Site Plan Review
REVISED
(3302 Glynn Avenue)

John Hunter
Director
Planning, Development, & Codes

Planning and Appeals Commission
Public Hearing
~~April 12, 2023~~
April 27, 2023

Revised Submittal

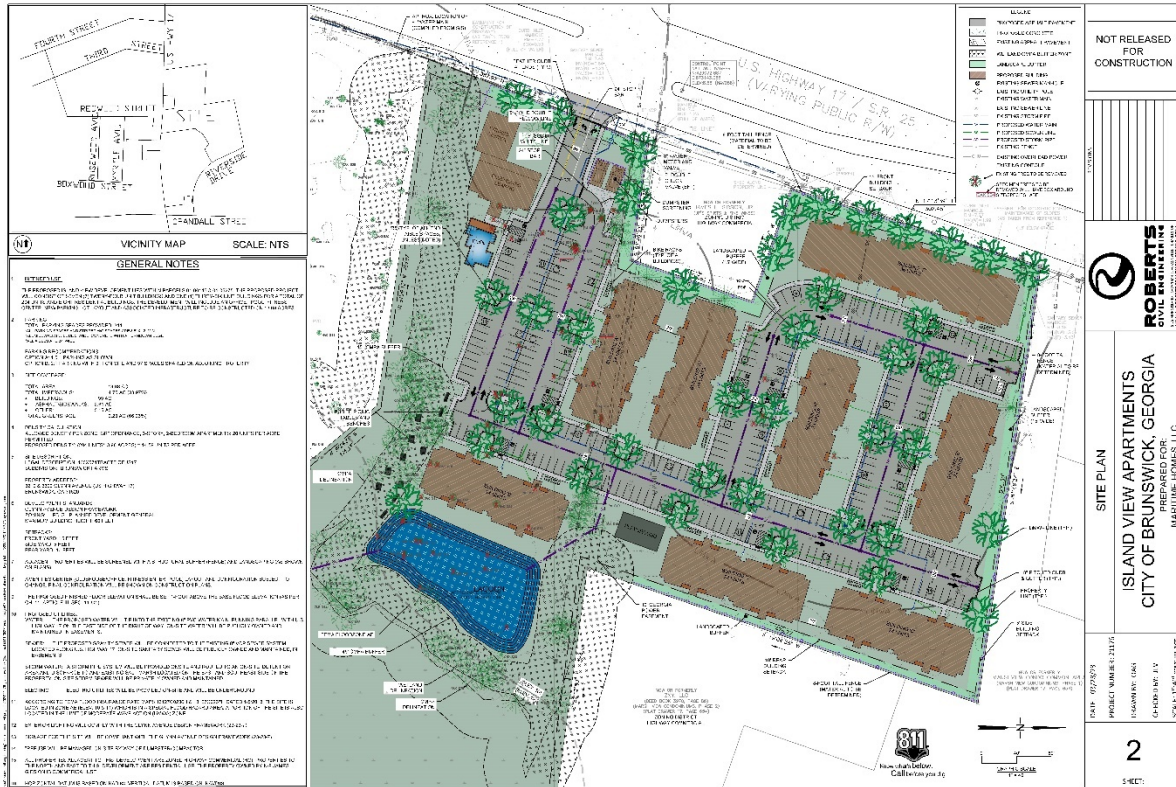
The applicant will be developing an additional neighboring parcel that is 3.25 acres in size. It will contain 1, three story building with 24 2 bedroom apartments. The additional parcel will also contain 92 parking spaces. This parcel will not be added to the Planned Development, but will be developed as a part of this project.

Because this is not being added to the Planned Development, the additional parcel is not subject to review by the PAC. However, it does have an impact as it addressed the parking concern for the project. The total of units as shown total 228. Under our ordinances, this would require 456 parking spaces. The total parking provided on the site plan is 403.

Parking requirements in multi-family and commercial developments are a major topic of discussion in planning currently. Parking is a hard cost, and developers typically look for ways to reduce parking and manage it via assigned spaces or limiting the number of vehicles per unit. Planners and City Engineers are looking more closely at requirements as they have significant impacts on stormwater, viability of developments, and environmental impacts. Cities of Brunswick's size have varying approaches to requirements that range from 1.5 spaces per unit to 2.25. When factoring unit vacancy rates, tenant work schedule variations, and the general flow of traffic day to day research shows that most multi-family developments can absorb a reduction of 5-10% of parking without issues. 403 spaces would reflect a reduction of roughly 11% versus the required amount.

Parking also has significant impacts on stormwater management. We are encouraged daily to reduce impervious surfaces and increase areas of natural retention. The Glynn Avenue Design Framework calls for us to consider best practices for stormwater management, and conceptually provides for it by the use of shared parking, street parking, and utilization of pervious surfaces. In staffs opinion, increasing the parking would provide a negligible amount of benefit when compared to the impacts on stormwater and greenspace.

Based on the previous review and the above information, staff recommends that the PAC recommend approval of the 90% site plan.
